DATE: July 29, 2024
S2 PROJECT #: 224034
PROJECT NAME: Whistler Municipality Alternative Solutions

ADDENDUM # 01

This Addendum No. 01 is issued to extend the bid submission deadline for the above-referenced project, provide revised Architectural drawings, and to answer RFI's submitted by the general contractor.

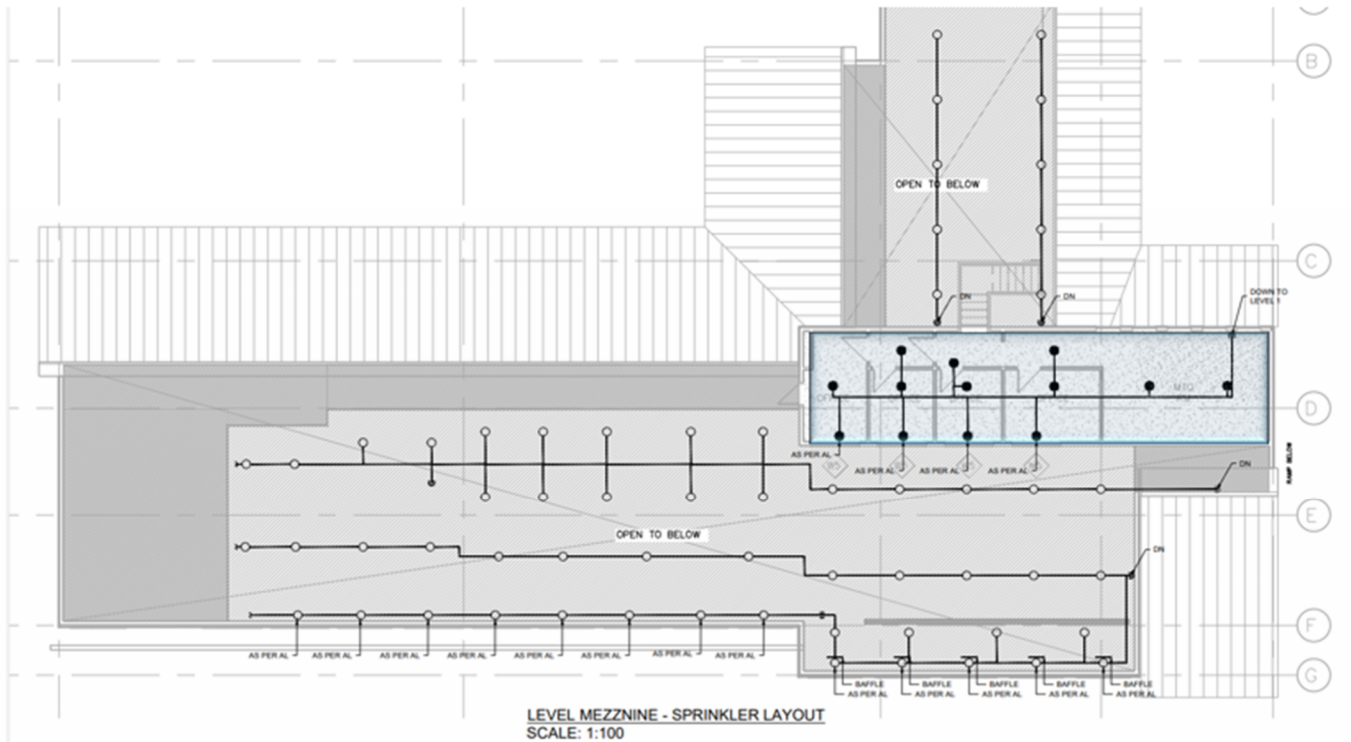
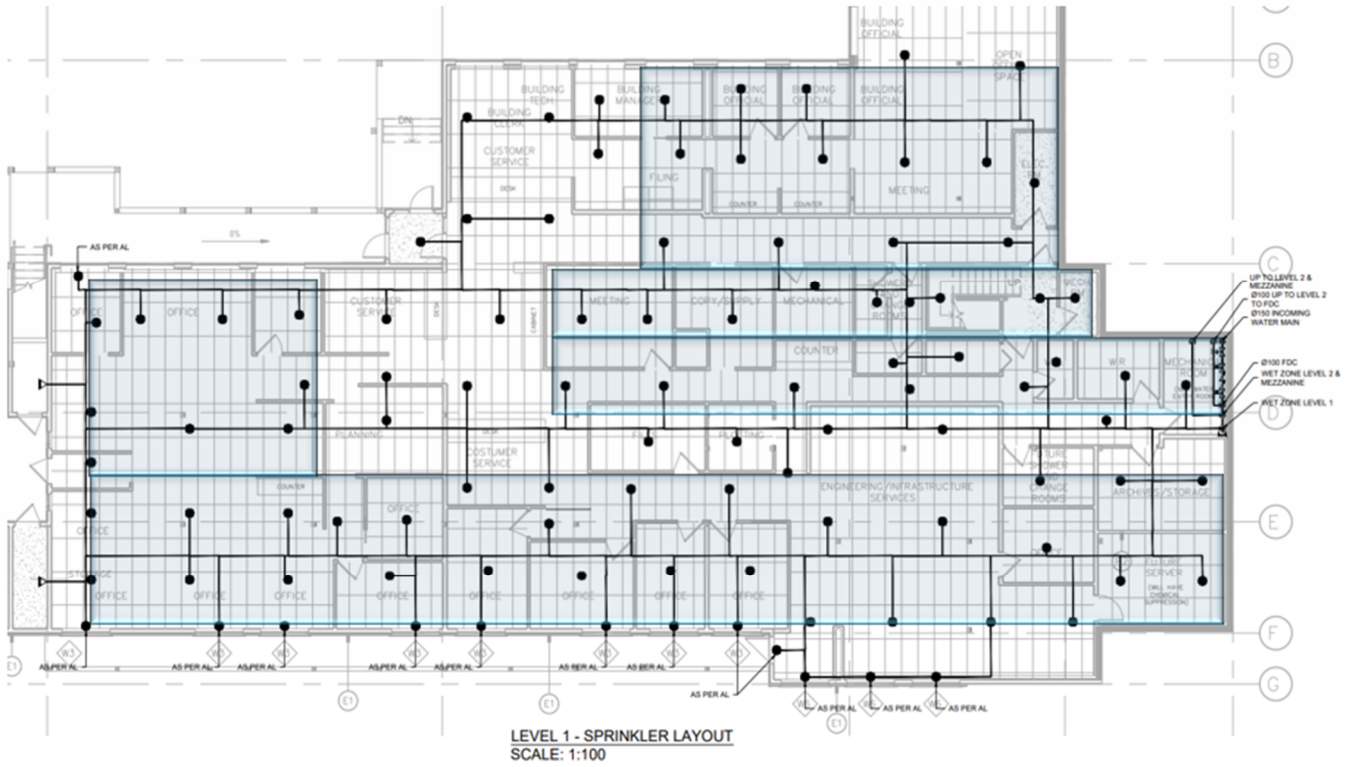
Q2. Please confirm new and existing mech room floor finishes

A) Remove portion of existing tile where we will be trenching, patch and repair concrete slab to make ready for new tiles. RMOW has spare tiles, GC to confirm prior to installation to ensure there is enough. Ensure proper slope around floor drain.

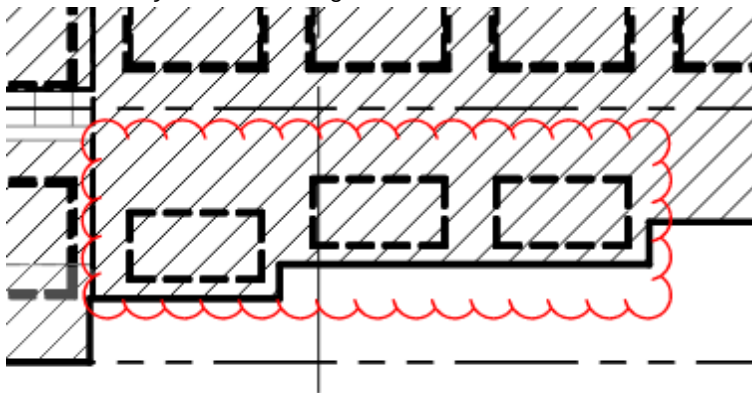
- A4.02 The 3 windows below are shown to all the all the others on this elevation and the demolition legend does not define this style. Is something different to be done with these windows?

A) Dashed line currently shown in elevation drawings indicates existing windows to be removed.

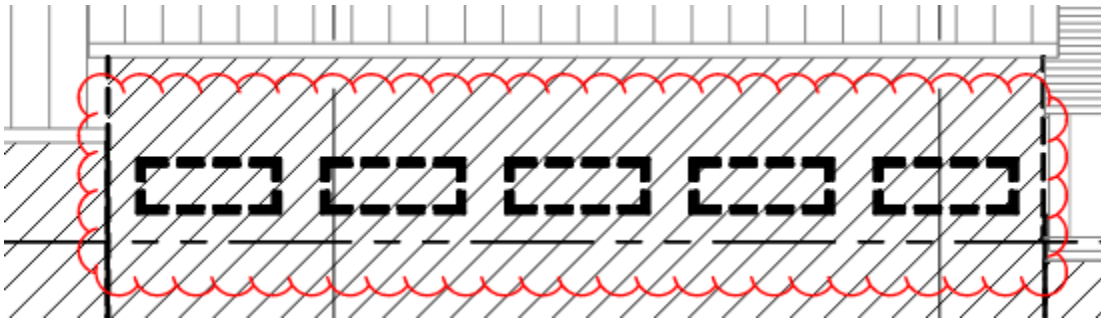
- A4.02 The 5 windows shown below are currently not aluminum windows and look to be steel frame with wire glass. Please confirm if these windows are to be removed and replaced with new aluminium windows

A) Windows to remain, refer to revised drawings issues with Addendum #01.

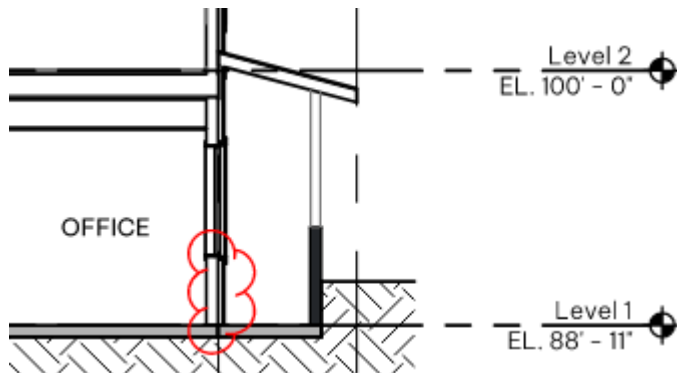
- A5.01 Section 3 Grid Line F - The wall below the window here is currently exposed concrete foundation wall. What is the new proposed finish to be? Is concrete faced rigid insulation to be installed 12" below grade in this location as detailed in Detail 6 on A6.01?

A) New finish to extend to concrete walkway, refer to A6.03 for updated details
